# New Park on Glengarry Avenue

## What We Heard: Concept Designs

April 2021

Figure 1 Early concept plan for the new park on Glengarry Avenue.

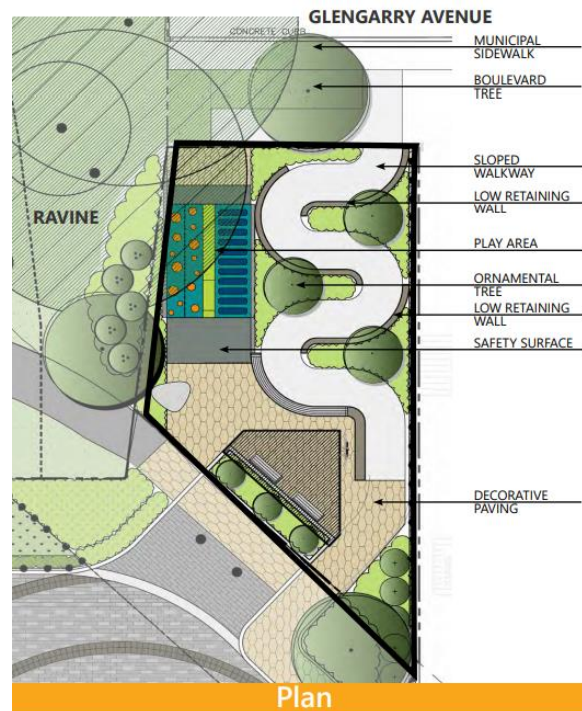
10. Can steps be swapped out in lieu of the curvy pathway?

1. **Expanding the playground area in size and including more variety of equipment:**
  - Several respondents commented on the size of the playground area and that it would not be sufficient in size due to the amount of use it would receive from young children in the area.

## **2. Reducing the amount of concrete and paved pathways for more natural green space**

## **4. Addition of a drinking water fountain to the park concept design**

**Staff Comment:** The curved pathway is required to provide an accessible pedestrian connection to the Park and from Glengarry Avenue to Lawrence Avenue. Steps are not considered accessible under the AODA Act.

**Staff Comment:** The size of the play area is limited due to the size of the park site, the requirement for an accessible walkway and the existing slope. While it may be smaller than other typical play areas, the sloped conditions will allow for a unique and fun play experience.

- The pathways are necessary to provide essential connections between public roads and to the adjacent ravine.
- The necessity for an accessible pathway and a gathering space next to the play area limits the ability to provide more green space within the park. However, the park is connected to the adjacent ravine which will provide a significant amount of natural green space.

**Staff Comment:** Due to the small size of the park and servicing constraints, a water fountain or splash pad cannot be accommodated.

### Concept Design

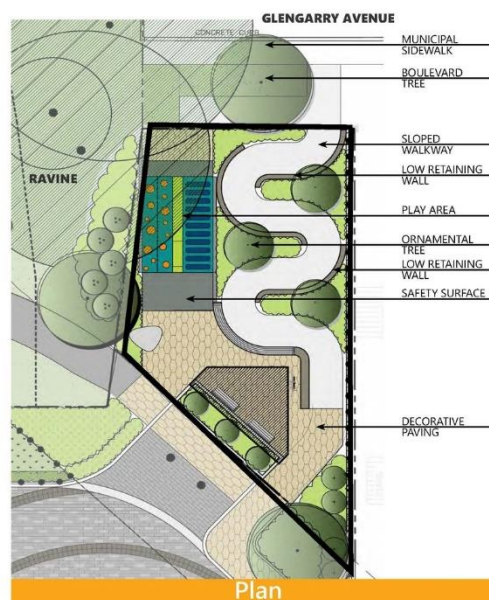
- The sloped pathway takes up 50% of the small parkette, then comes the play area.....the sitting / gathering space has the least amount of space designated to it. I see the parent(s), sitters using the gathering space while the children play.....leaving no space for others to use. Seems that the whole design is driven by space and activity for children.

- Am concerned about the degree of slope on the Children's play area - think this needs to be extended out to be a lesser degree angle. Seems to be very little sitting area and some of it that exists is on benches with no backs.
